SERVICE BULLETIN

OIL - REPLACE THE FUEL COOLED OIL COOLER (FCOC) MOUNT BRACKET - CATEGORY CODE 4 - MOD.ENG-79-0021

- (1) Aircraft: Airbus A320
- (2) Engine: V2500-A1 Engines prior to Serial No.V0146

FCOC Mount Bracket, Pin and Bushing
Fig.1

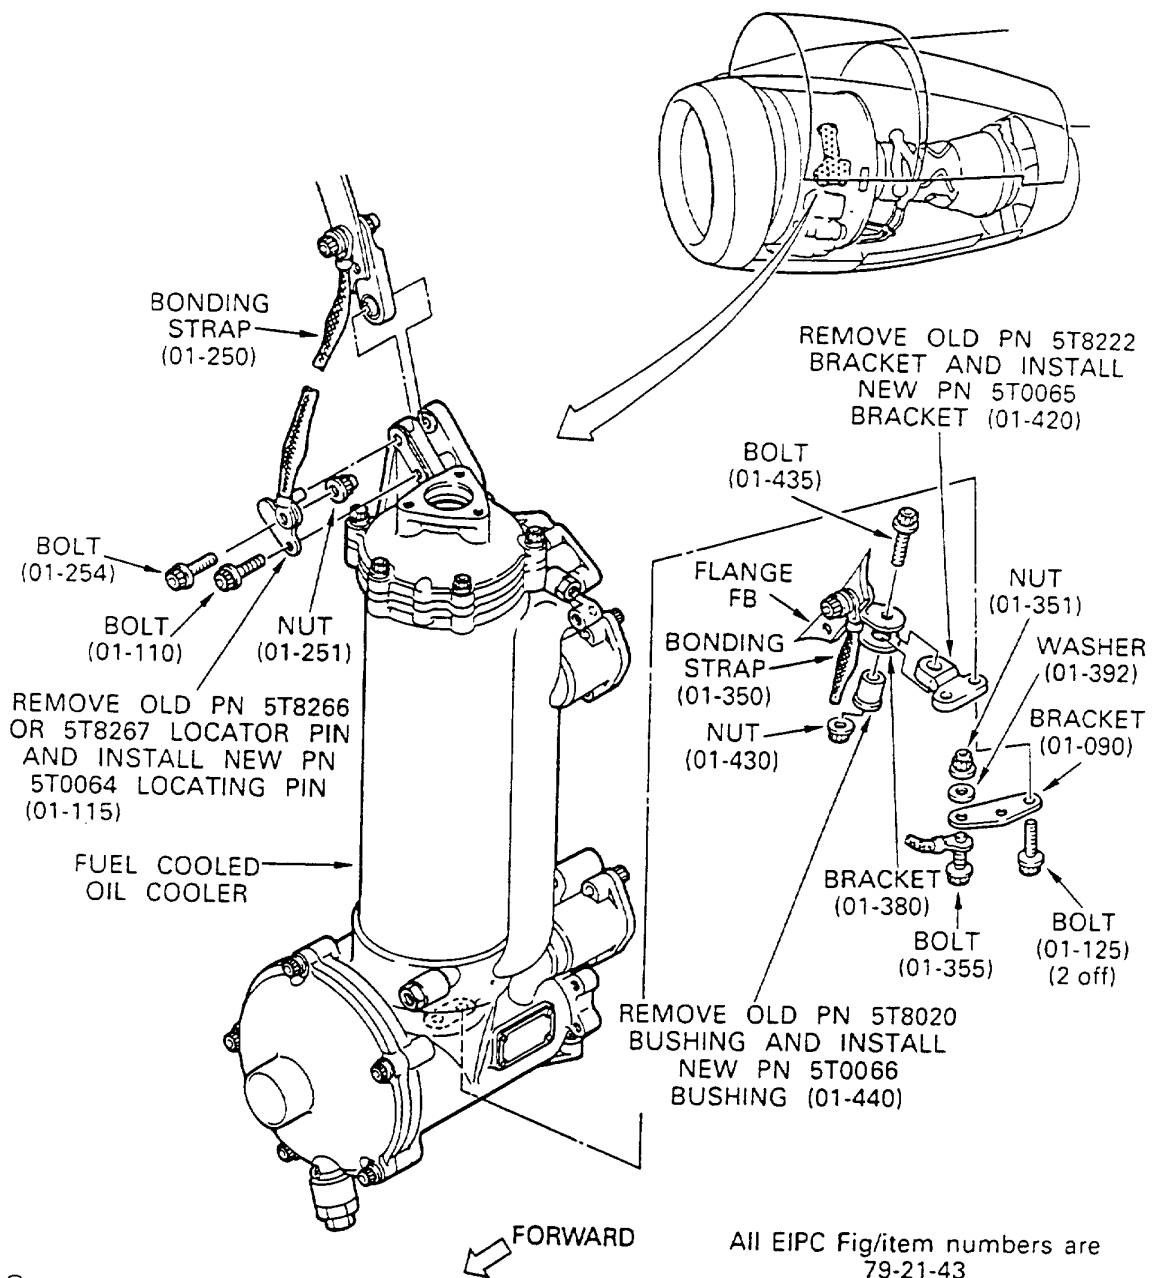
- (a) The anti-fretting coating is applied to the pin and bushing.
- (b) The material of the brackets is changed.
- (c) Fit clearances are reduced between the pin and the bracket and between the bushing and the bracket.

- (1) Remove the two bolts (79-21-43, 01-125), the Bracket (79-21-43, 01-090) and the old 5T8222, Bracket (79-21-43, 01-420). Refer to Figure 1.
- (2) Replace the old 5T8267 or 5T8266, Pin, Locator (79-21-43, 01-115) with the new 5T0064 Pin, Locating. Refer to Figure 1.
- (3) Replace the old 5T8020, Bushing (79-21-43, 01-440) with the new 5T0066 Bushing. Refer to Figure 1.

- (1) Install the bracket (79-21-43, 01-090) and the new 5T0065 Bracket (79-21-43, 01-420) to the FCOC with the two Bolts (79-21-43, 01-125) and torque the bolts to between 85 and 105 lbfin (10 and 12 Nm).
